Re: FortisBC Energy Inc. (FEI)

**Application for a Certificate of Public Convenience and Necessity for the
Okanagan Capacity Upgrade Project (Application)**

**Response to the Residential Consumer Intervener Group (RCIG) Information
Request (IR) No. 1**

Blue borders: Class 1 / Green : Class 2 / Dark Yellow: Class 3

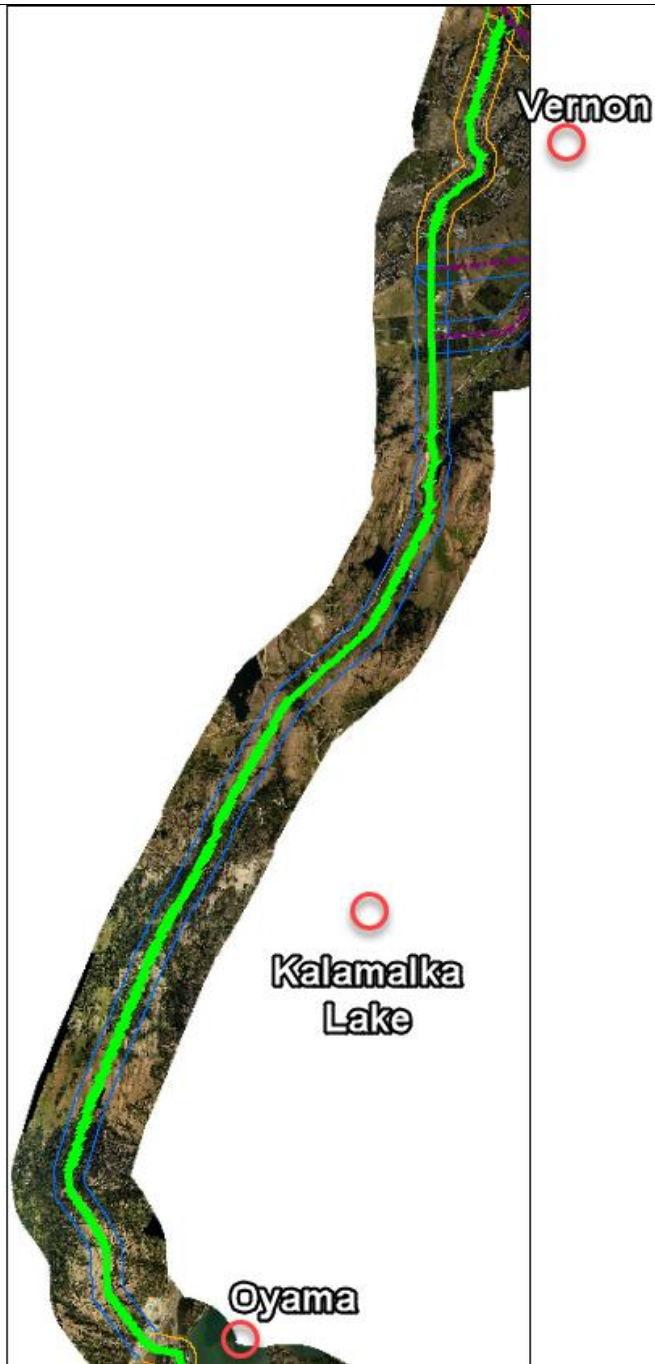
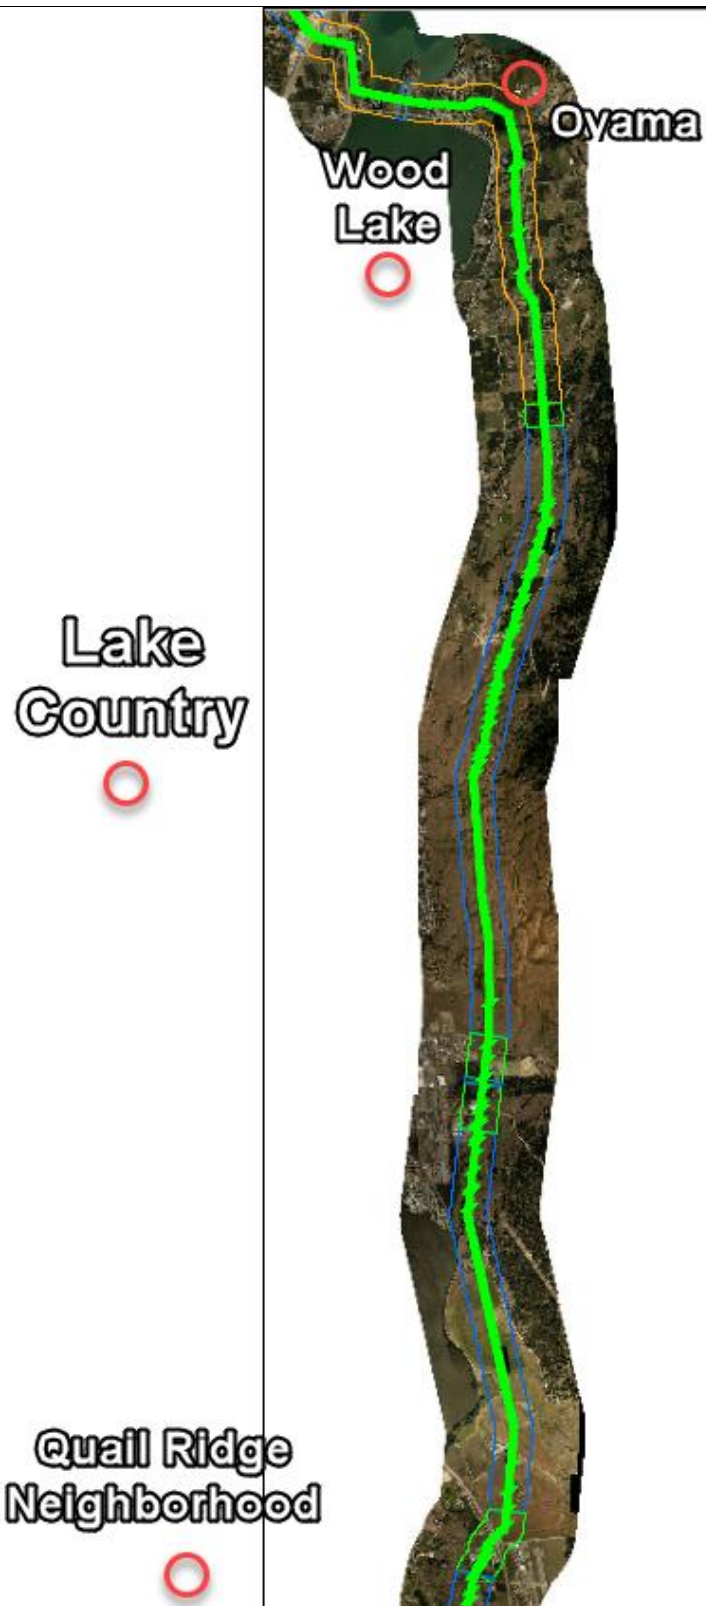
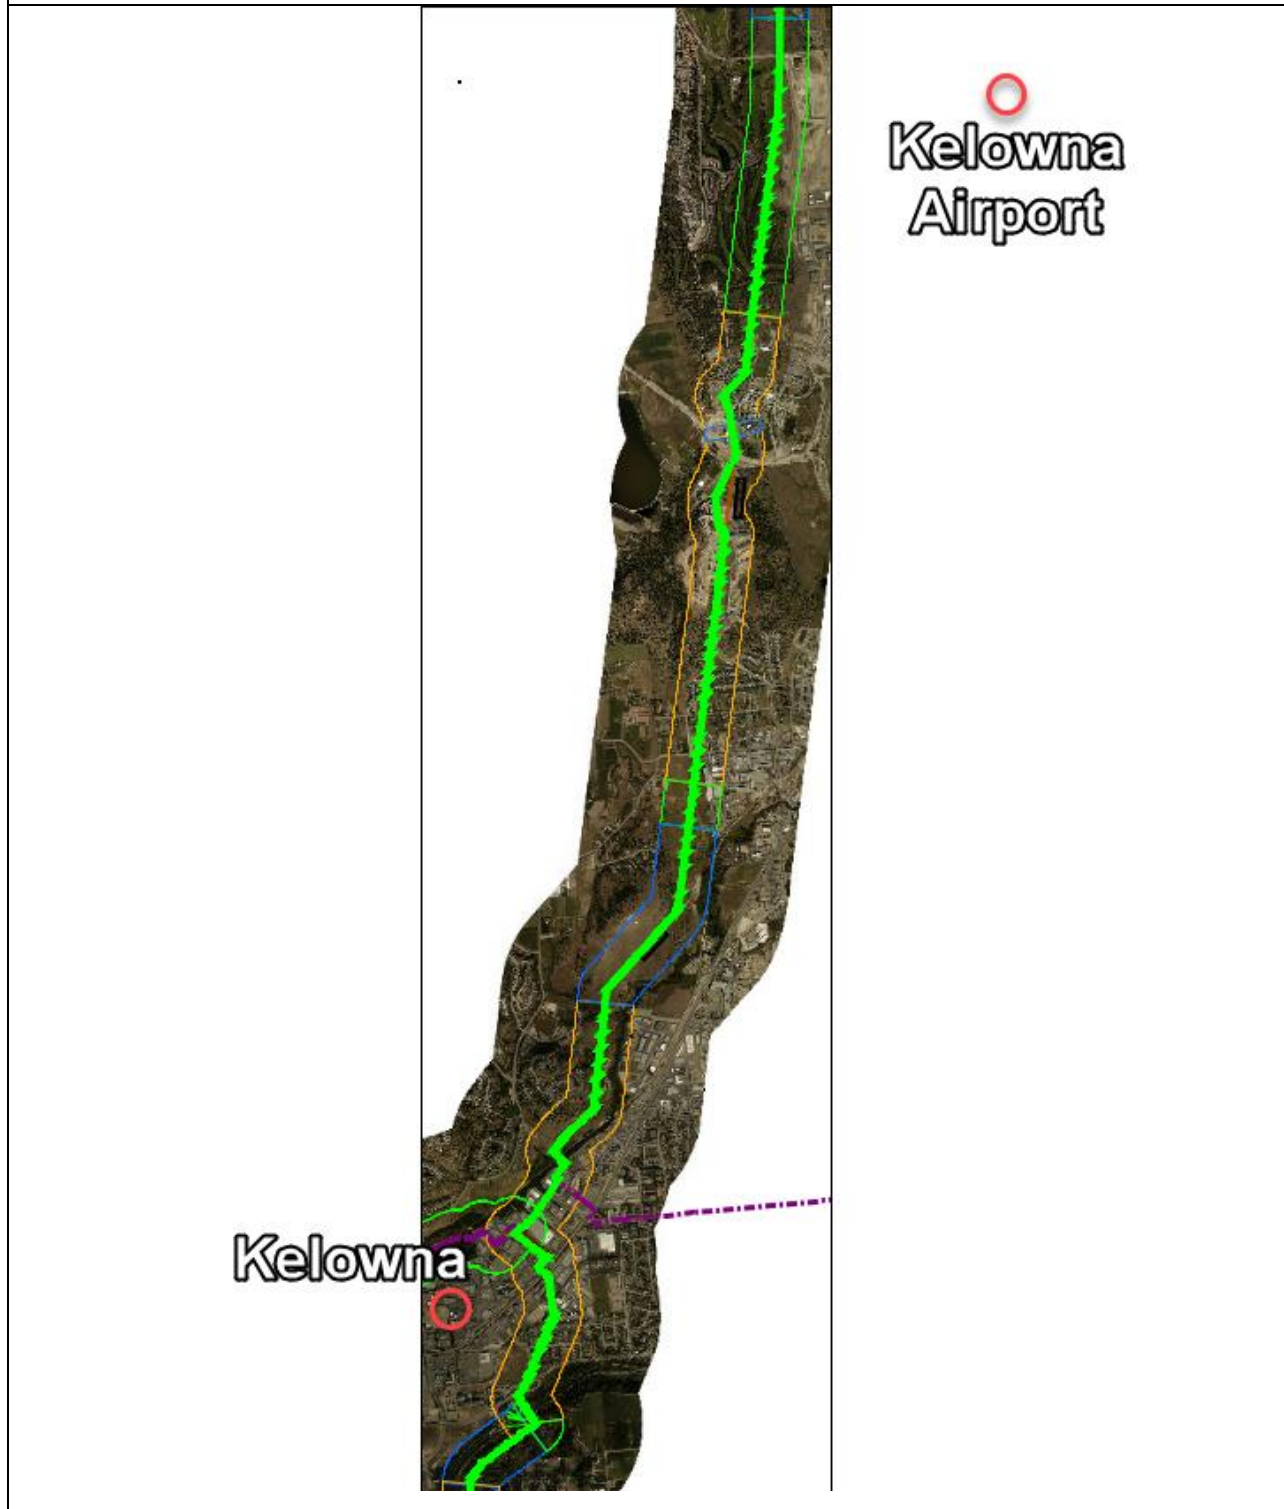
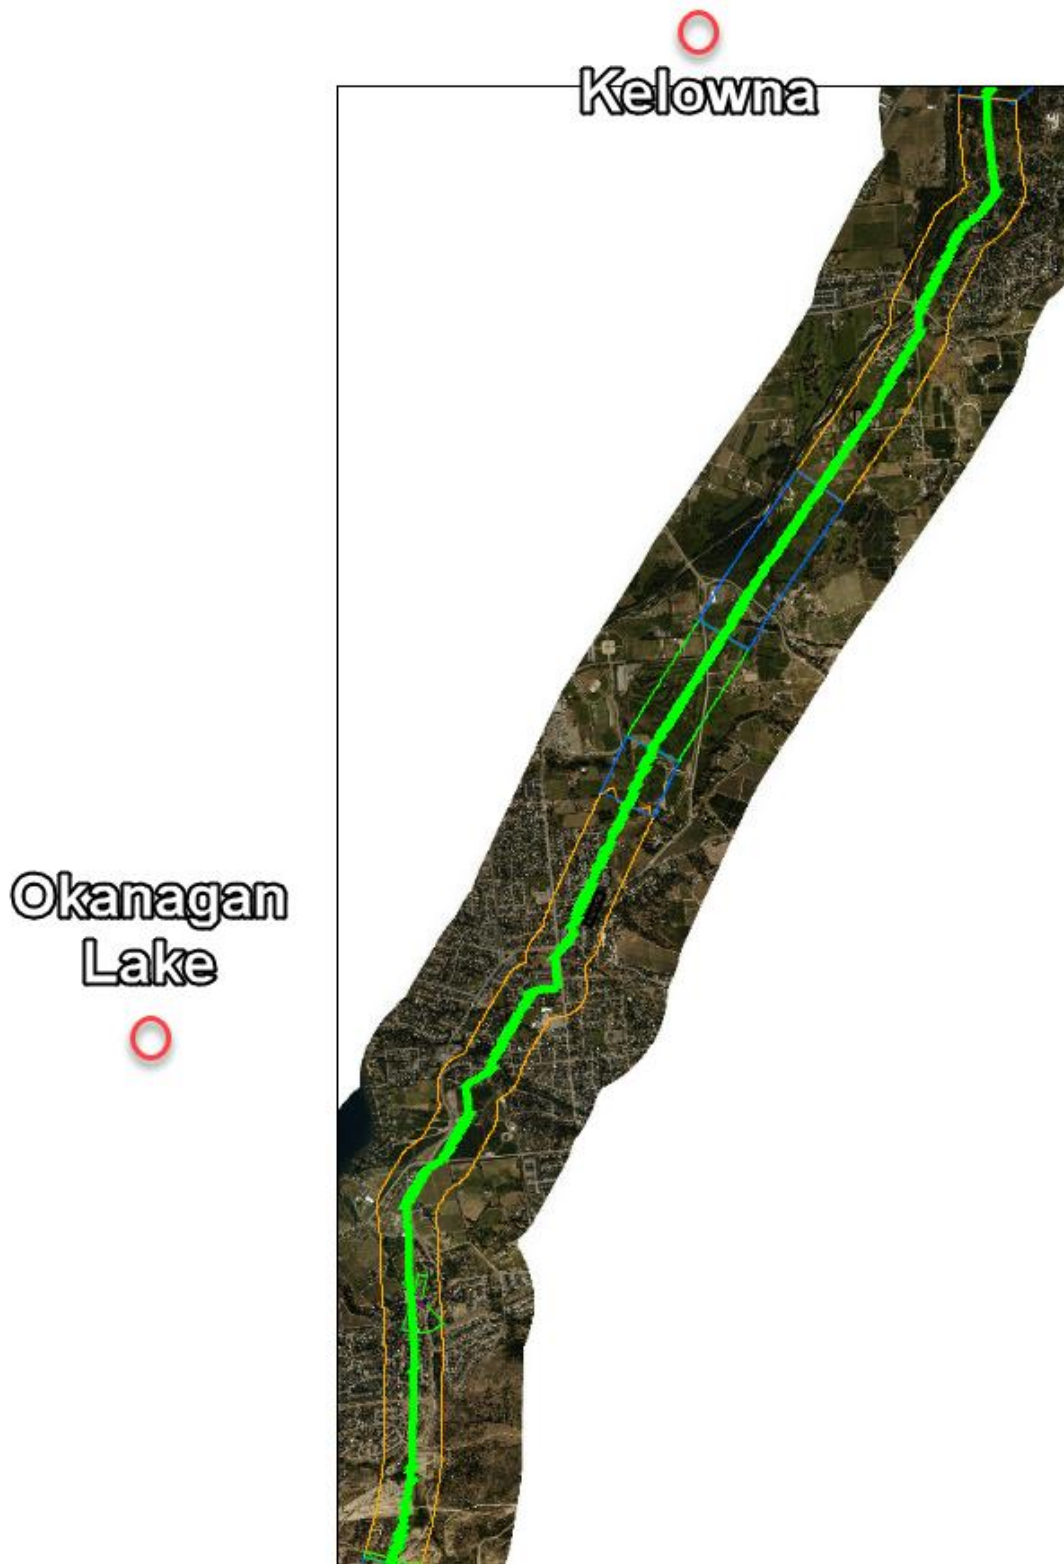
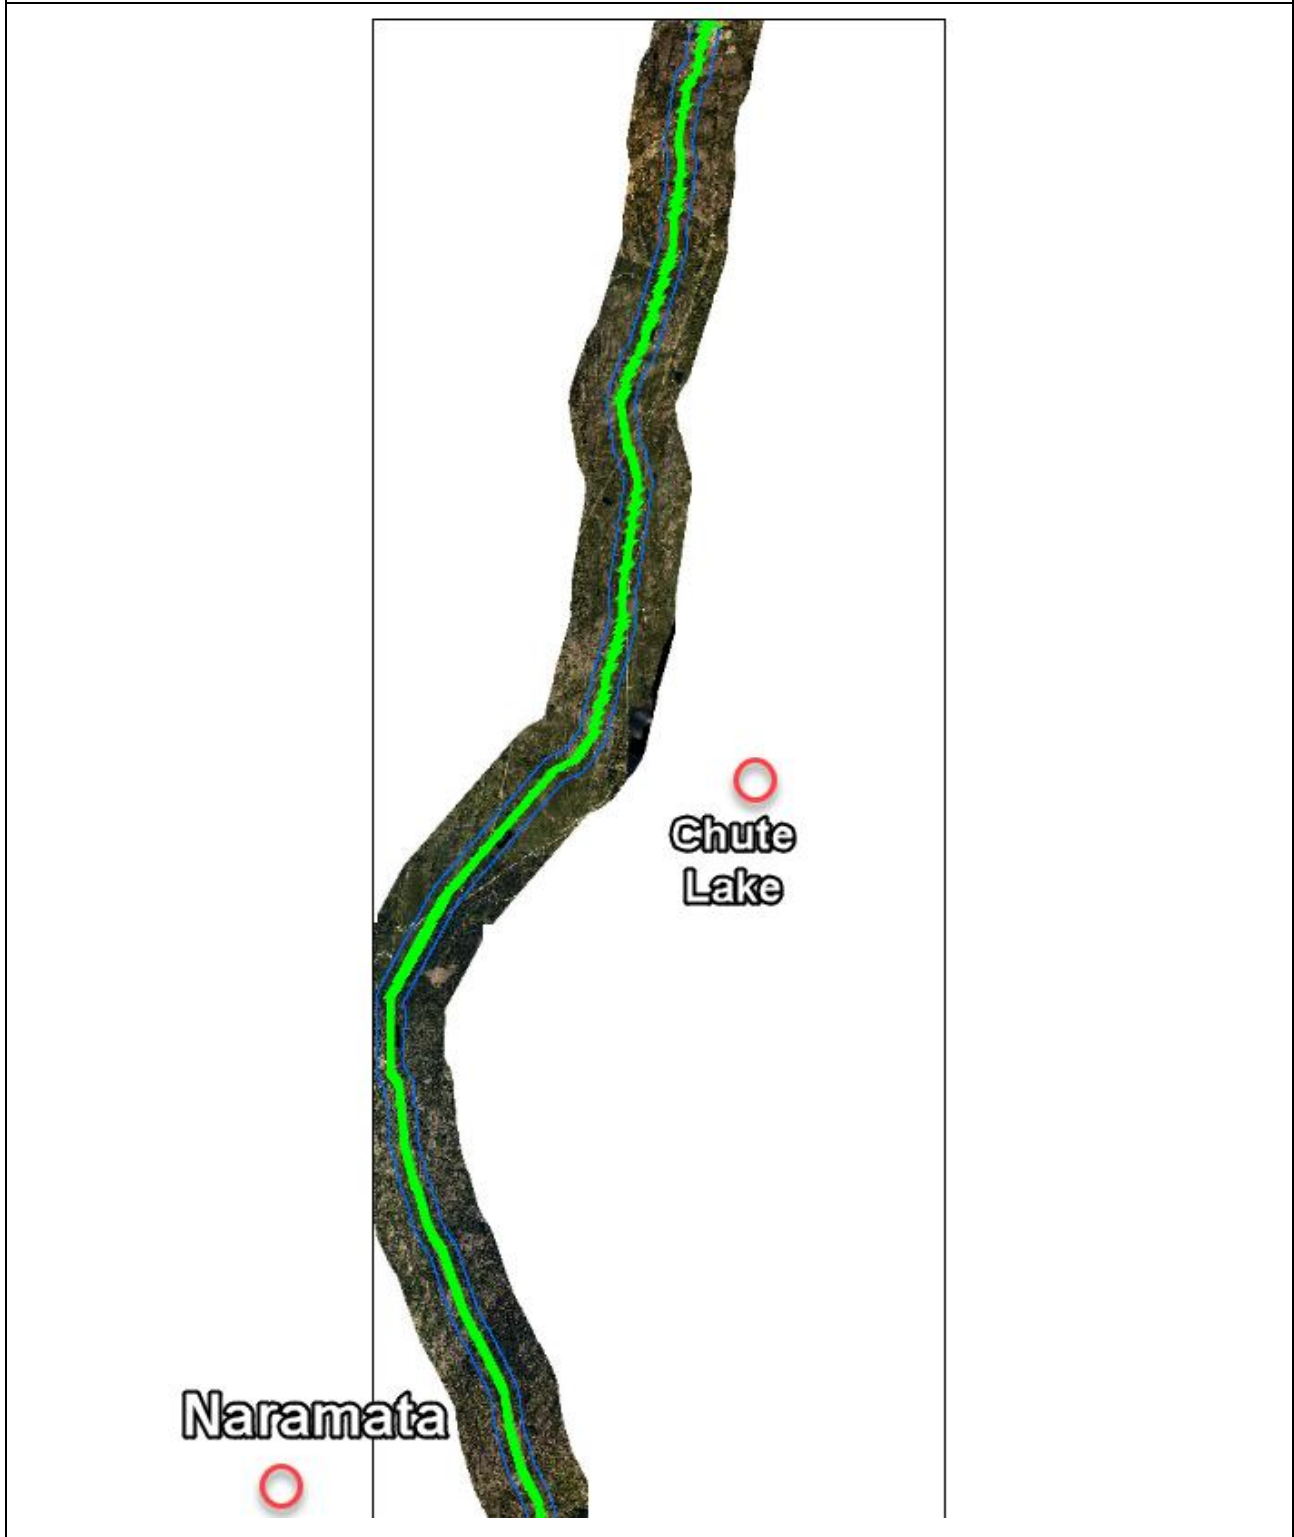
8.1 Provide a map of the VER PEN 323 line that shows the class locations along its length.

Class location changes cannot be shown clearly on a single map. Please refer to Attachment 8.1 for screen captures which show the full length of the VER PEN 323 pipeline in sections, with Class 1 locations outlined in blue, Class 2 locations outlined in green, and Class 3 locations outlined in dark yellow. Start and end points correspond to metres along the pipeline, starting from the north end of the VER PEN 323 and terminating at the south end of the VER PEN 323, a length of 98,994.444 m or 98.99 km. This information is also provided in the table below.
